LPS GROUP B
ACCESS CONTROL UPGRADE

PROJECT NO.
20155337

DRAWING REFERENCED: 222.E01
ADDENDUM NO.: 02

SKETCH
T S-002

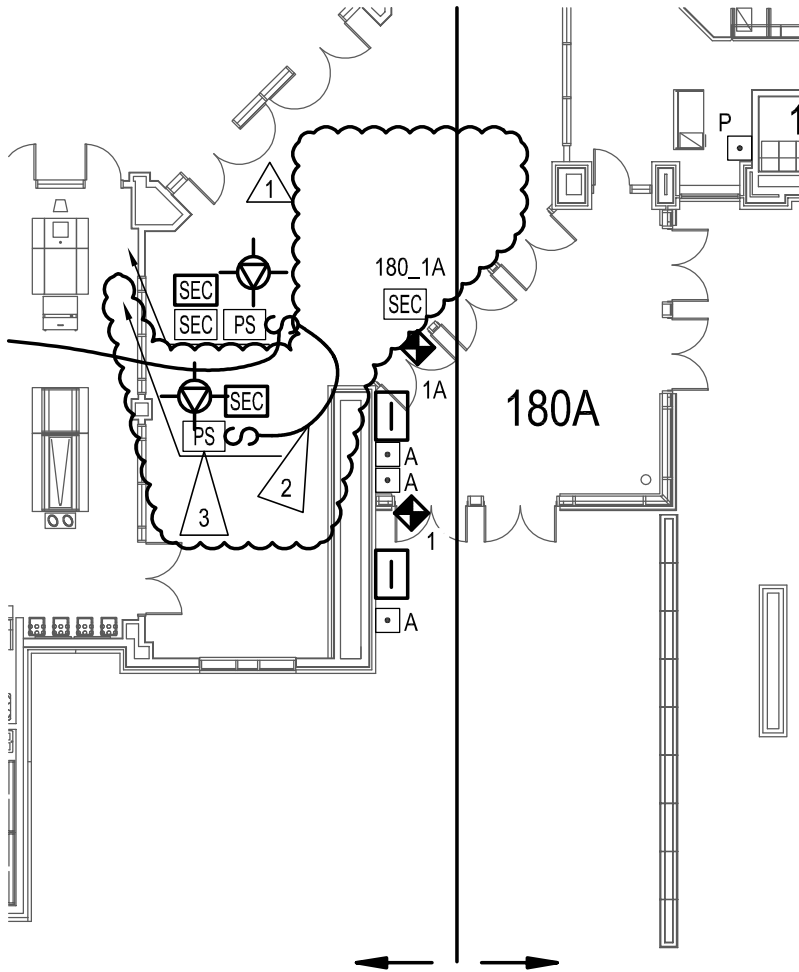
2TD1. Sheet 222.E01 – Schoo Middle School – Floor Plan – First Floor

1. Door 180_1A: Relocate the existing power supply/enclosure and new door controller/enclosure to be located adjacent to the existing power supply and controller enclosures for Door 180A_1 located in Room 101. Existing Door 180_1A power supply and enclosure are located above the ceiling in Vestibule 180. Ceiling is approximately 30 feet tall. Utilize existing and new pathways to extend the cabling up to the ceiling within vestibule and down to above ceiling in room 101. Ceiling height in Room 101 approximately 10 feet tall. Install new cabling from ADA operators, ADA paddles, exit devices, card reader, door position switch, and any other devices to new door controller location. Contractor provided lift will be required and all floors and surfaces must be protected during installation. See attached Sketch Sheet TS-002.

1 3 RELOCATE EXISTING DOOR 180_1A POWER SUPPLY LOCATED IN CEILING ABOVE DOOR 180_1A, TO ROOM 101 LOCATED ADJACENT TO EXISTING POWER SUPPLY AND DOOR CONTROLLER ENCLOSURES FOR DOOR 180_1A. UTILIZE EXISTING POWER SUPPLY AND NEW DOOR CONTROLLER FOR THE ELECTRONIC ACCESS CONTROL ON DOOR 180_1A.
